**RE: Lot 15 Block 2, Volcano Cliffs Unit 19, SAD 228
6508 Camino Del Oeste NW
Grading and Drainage Plan
Engineers Stamp Date 11/28/17 (D10D003G15)**

RE: **6508 Camino Del Oeste NW
Lot 15 Block 2 SAD 228
Volcano Cliffs Subdivision
Grading and Drainage Plan
Engineers Stamp Date 11/26/17 (D10D003G15)**

GRADING & DRAINAGE PLAN
6508 Camino del Oeste NW
LOT 15, BLOCK 2, UNIT 19 VCS
 Sheet 2 of 2

ENGINEER'S SEAL  11/28/17 11/26/17 DAVID SOULE P.E. #14522	6508 CAMINO DEL OESTE	DRAWN BY WCMJ
	GRADING AND DRAINAGE PLAN	DATE 11-23-17
 1606 CENTRAL AVENUE SE SUITE 201 ALBUQUERQUE, NM 87106 (505) 872-5999		21811-LAYOUT-10-16-17
		SHEET #
		JOB # 21808

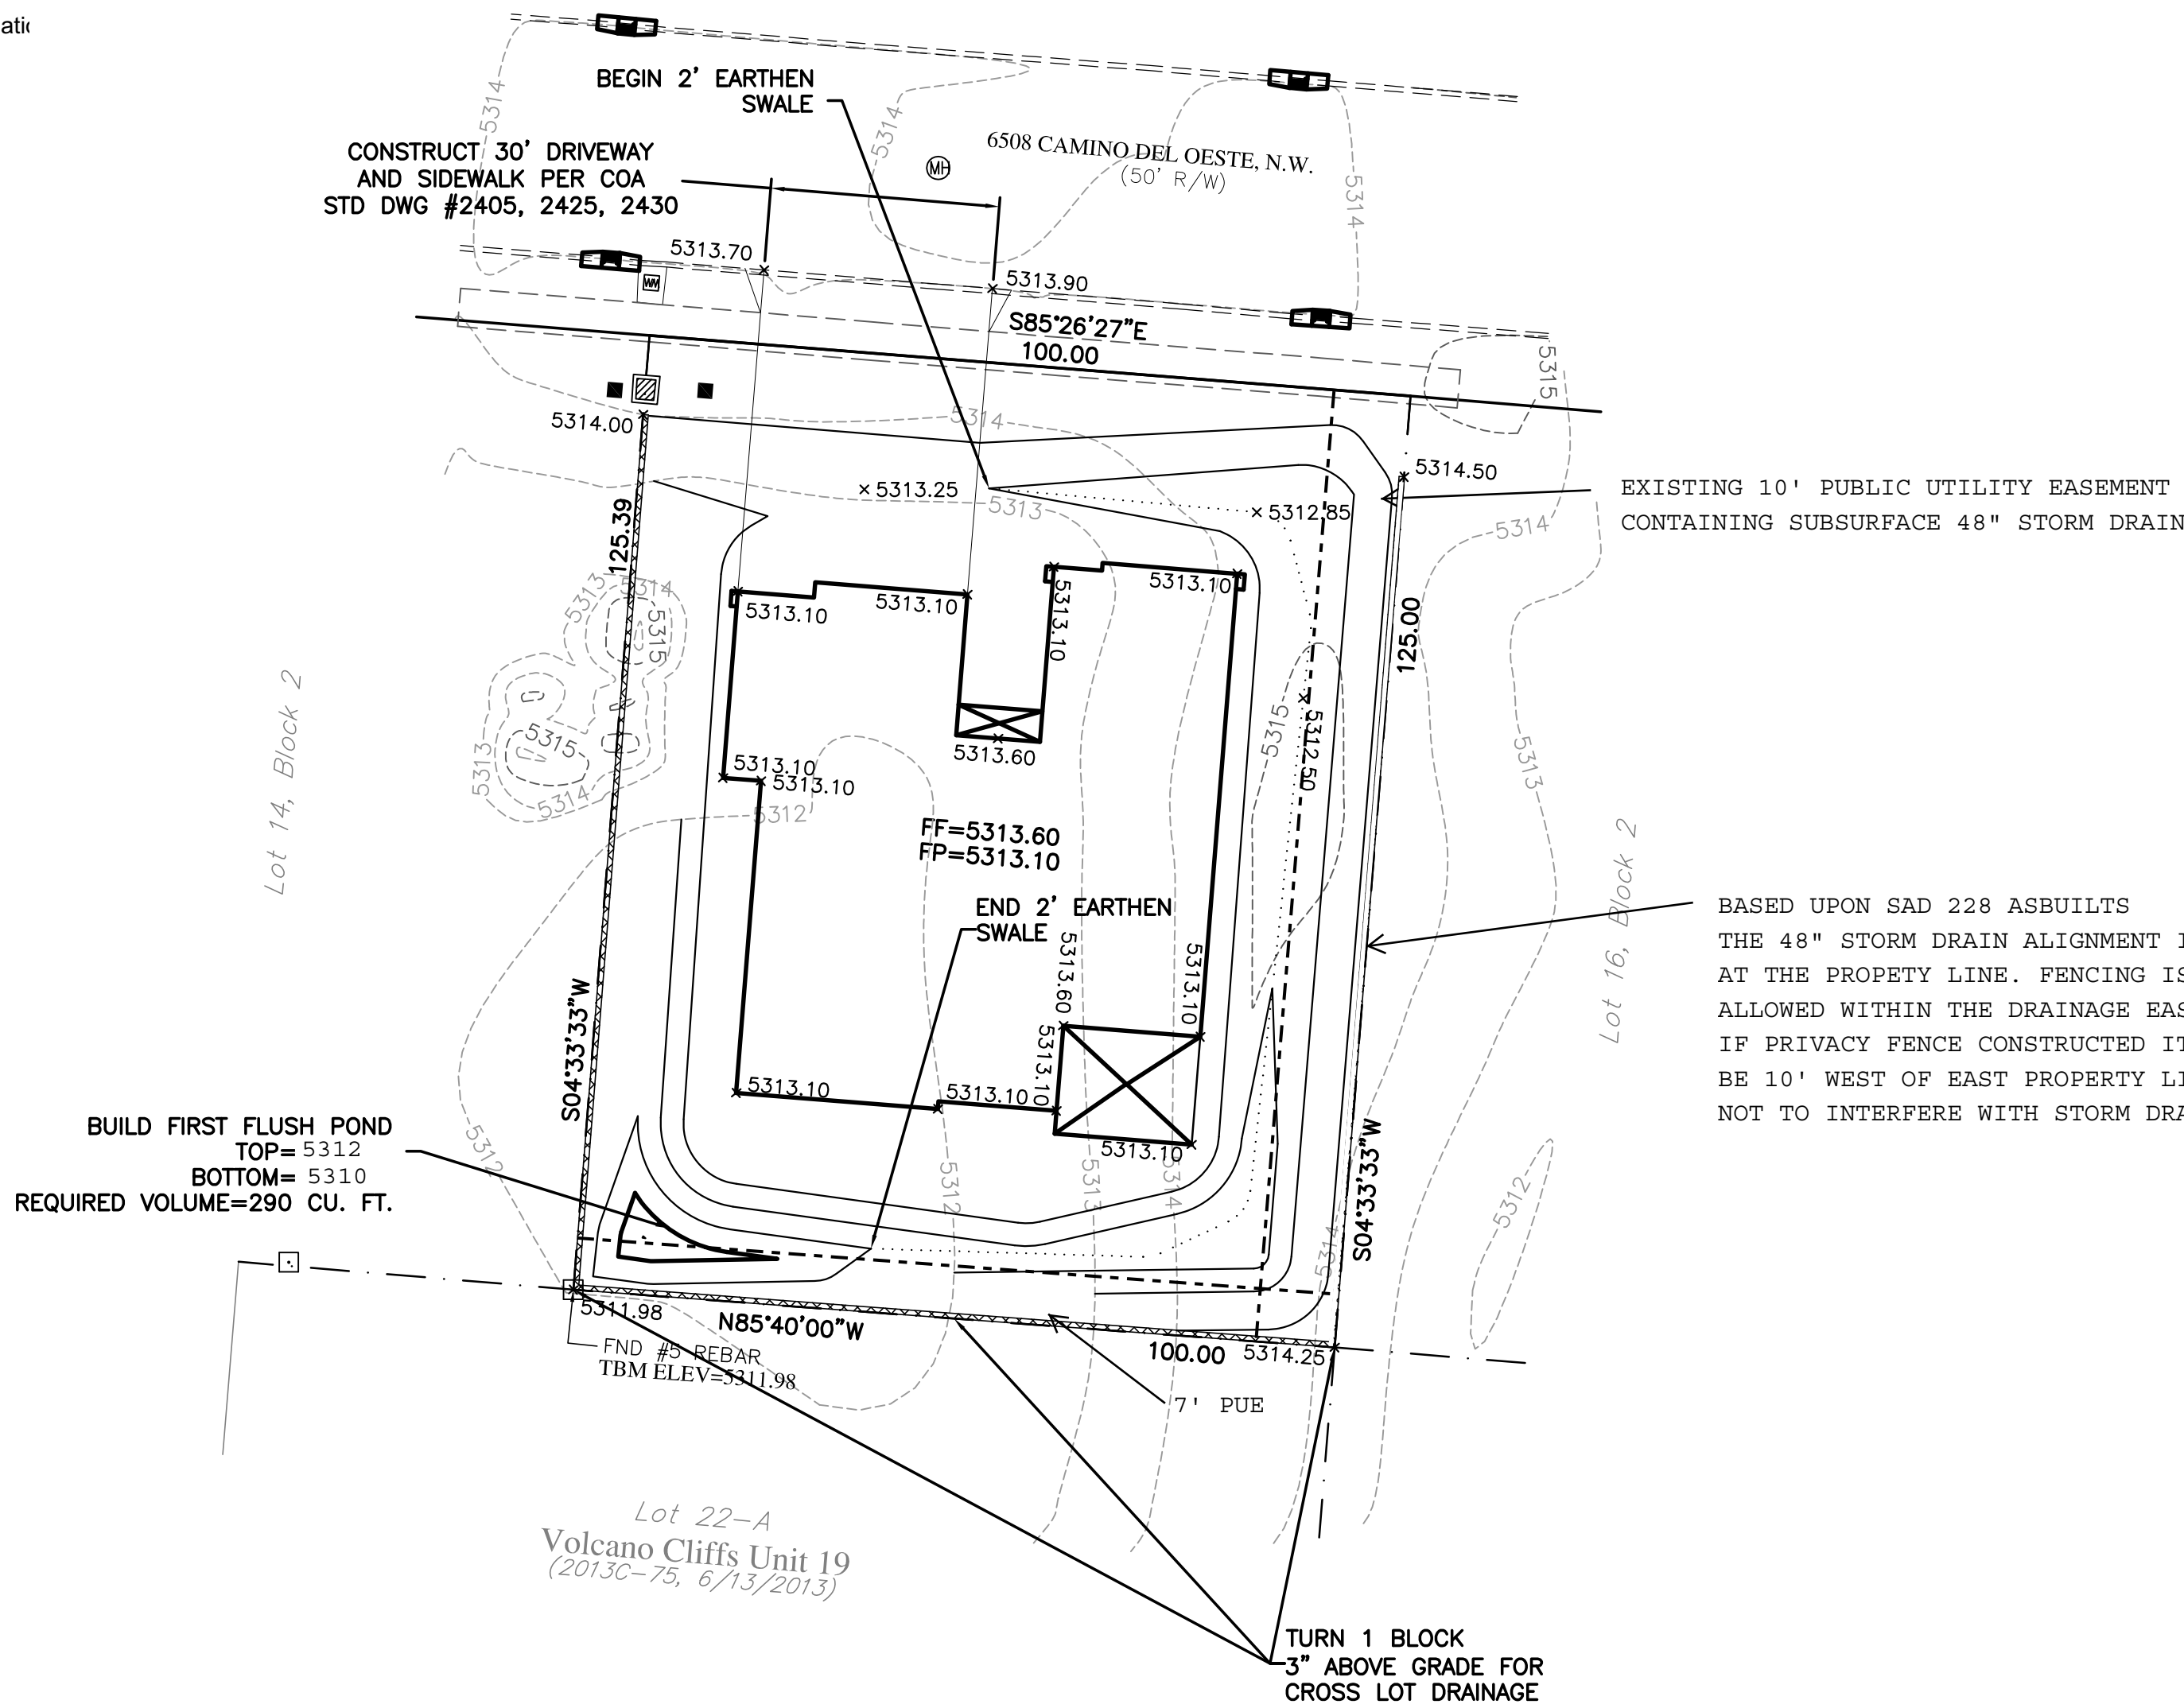
Reiterate to the Owner/Contractor that a separate permit for a garden/retaining wall must be obtained and the east garden wall will need to be 10 feet inside the property line, with an approved G&D plan and Pad Certification.

- Show the 10' PUE and the location of the 48" drainage pipe in the PUE on the east side of the property. **WE HAVE ADDED**
- Avoid placing the garden wall in this location. on top of 48" drainage pipe. **WE HAVE ADDED NOTE REGARDING STORM DRAIN**

DUE TO ZONING HEIGHT RESTRICTIONS, THE PAD COULD NOT EXCEED 20" FROM LOWEST ADJACENT GRADE. DRAINAGE PATTERNS AND HYDROLOGY ARE NOT CHANGED
